CD-1 Rezoning: 461–479 East 16th Avenue  
**Opposed: Unresolved Risk in a Mapped Peat Zone**

April 17, 2024 – City of Vancouver Public Hearing

**ENGINEERING REVIEW AND ASSESSMENT  
PRELIMINARY HYDROGEOLOGICAL INVESTIGATION REPORT  
PROPOSED 461-479 EAST 16<sup>TH</sup> AVENUE DEVELOPMENT  
VANCOUVER, BC**

## 1.2 ENGINEERING ASSESSMENT AND OPINION

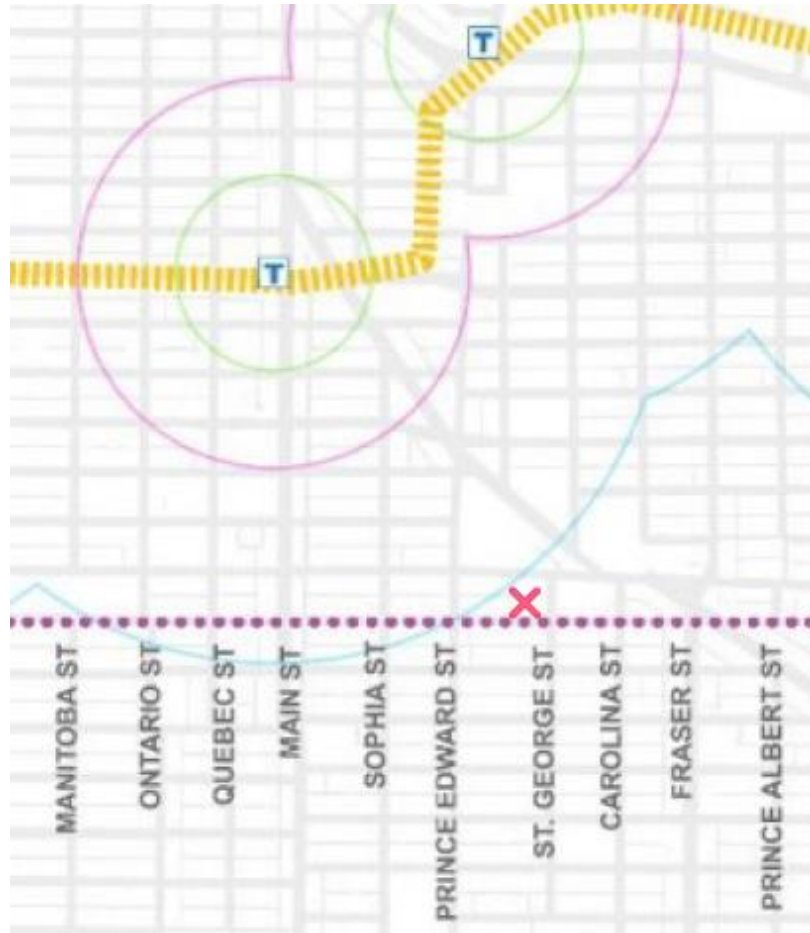
It is my opinion that the existing borehole and hydrogeological information in the GeoPacific report is not sufficient or adequate to meet the criteria of the City Bulletin for a Preliminary Hydrogeological Study, and that additional hydrogeological investigation and analyses should be carried out as part of a Revised Preliminary Hydrogeological Study, in accordance with Item 2.3.3 of the Groundwater Management Bulletin. In my opinion and experience, the groundwater levels and seasonal variations identified within the siltstone bedrock could vary, potentially significantly, from the groundwater levels within the peat, clayey silt, and glacial till soils overlying the siltstone bedrock. These potential or likely differences in groundwater levels and seasonal variations were not identified or addressed in the GeoPacific report. Specifically, it is my opinion that the GeoPacific assessment is not sufficient to exclude the risk and impact of damages to offsite structures and other facilities that could occur due to groundwater extraction or lowering within the moderately to highly compressible peat and soft clayey soils underlying the properties adjacent to and potentially significant distance beyond the P4 Parkade development site.
